ORIGINATION FORM

Proposed Revisions to a Standard Plans Index (Please provide all information — Incomplete forms will be returned)

Index Number: 700-030
Sheet Number (s): 1 of 5
Index Title: Dynamic Message Sign Walk-In

SHEET
1 of 5

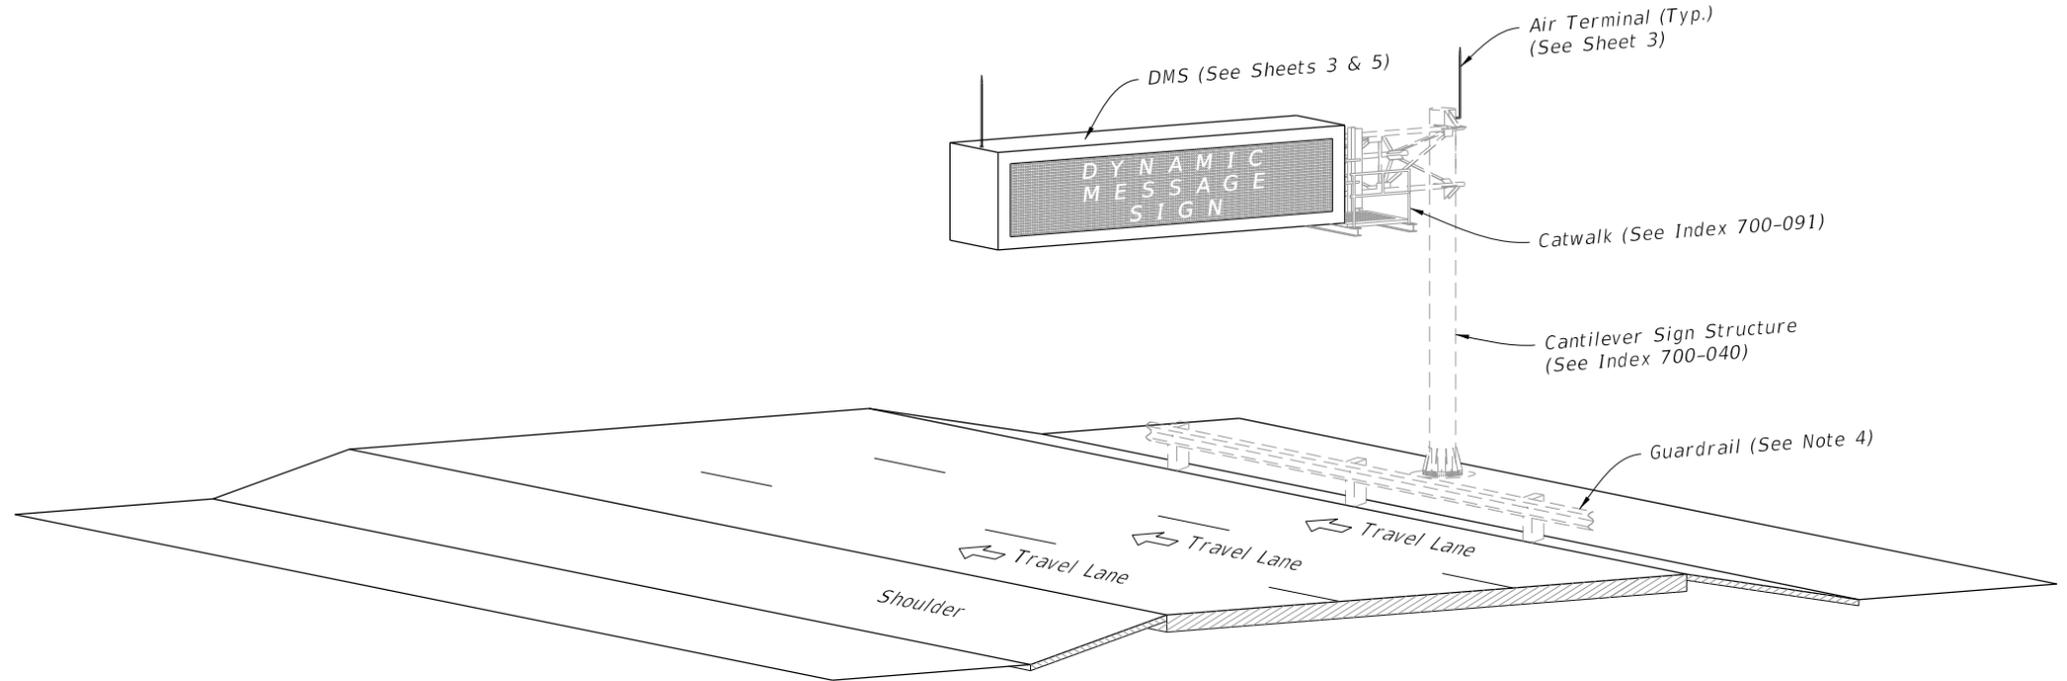
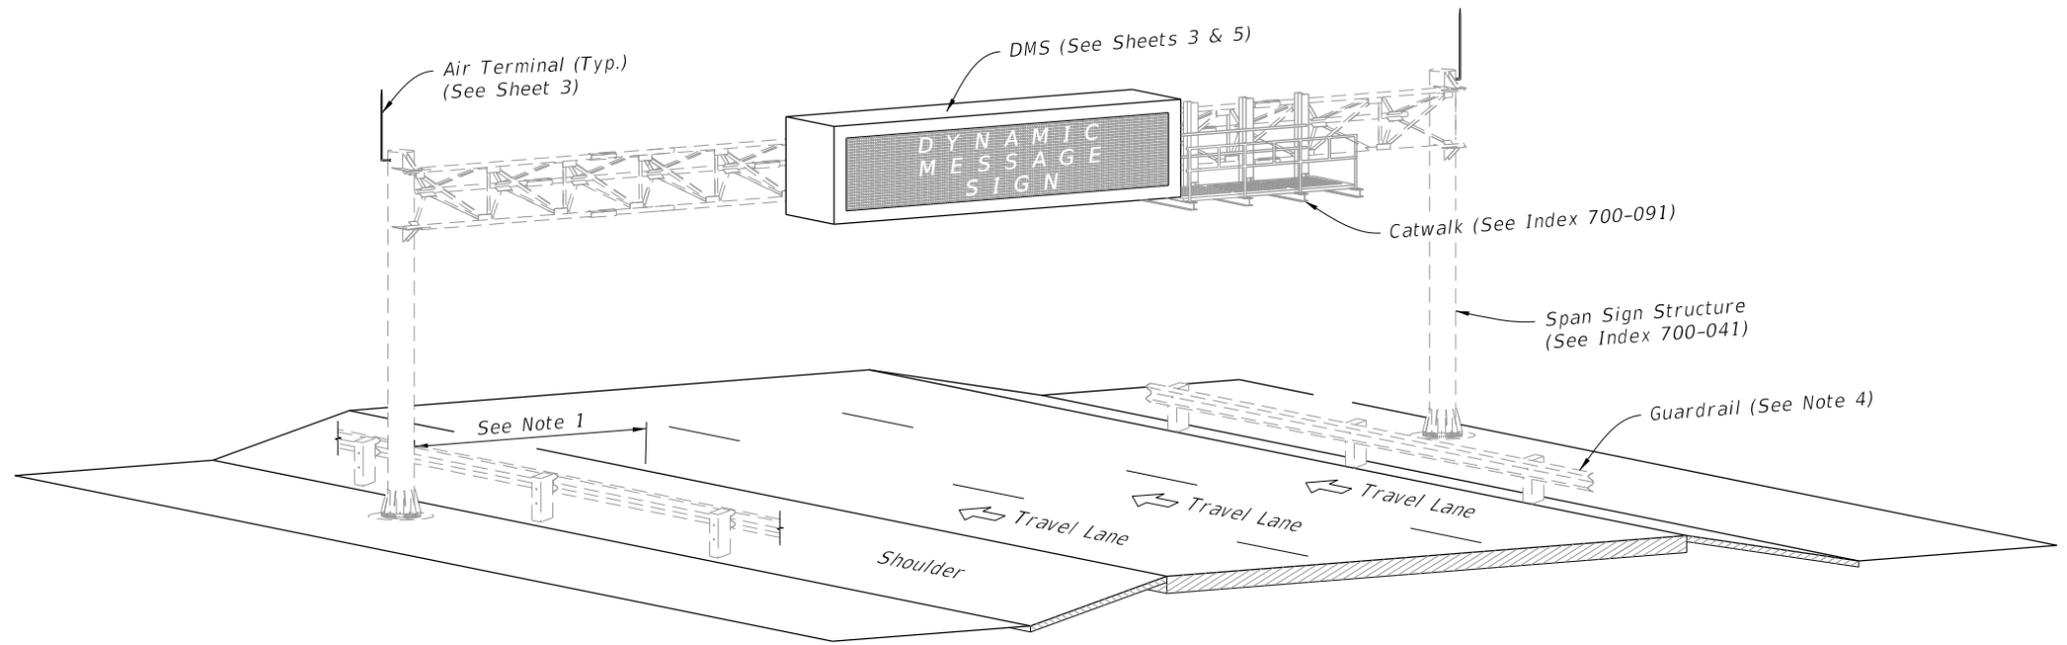
Sheet 1: Change Note 5.A.a reference to ASTM B308 to ASTM B221 throughout Standard Plans as an administrative change.

B221

ASTM withdrew B308-10 so need to change it to ASTM B221 in all applications.

DETAIL "E"

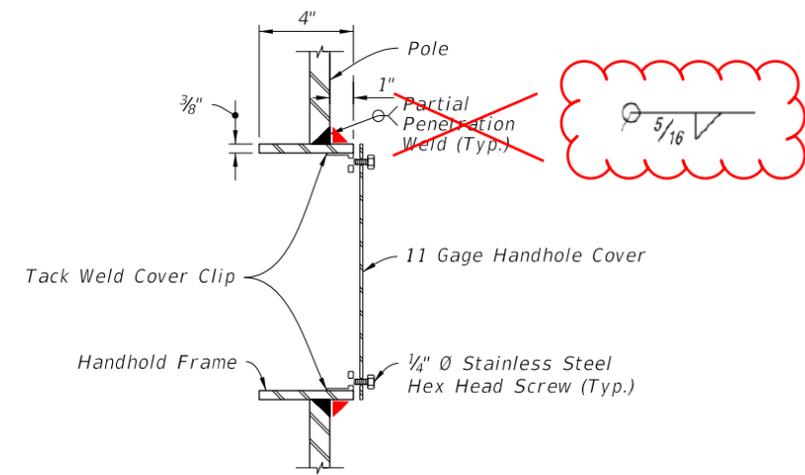
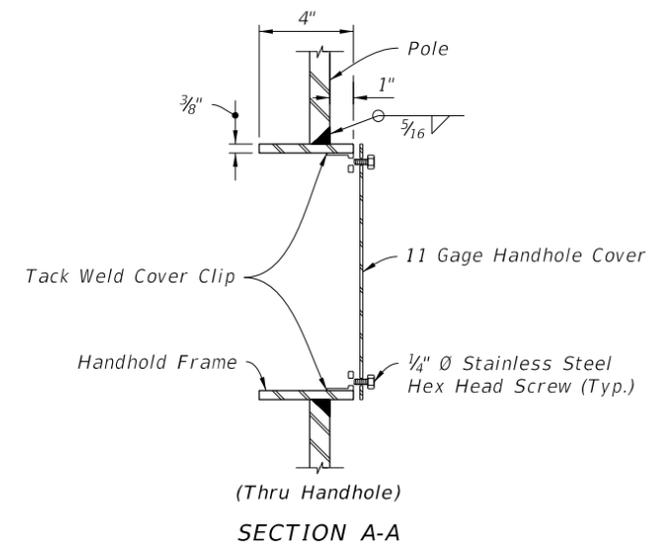
Sheet 4: Detail 'E' changed weld.

Change weld to meet current criteria as requested by industry.
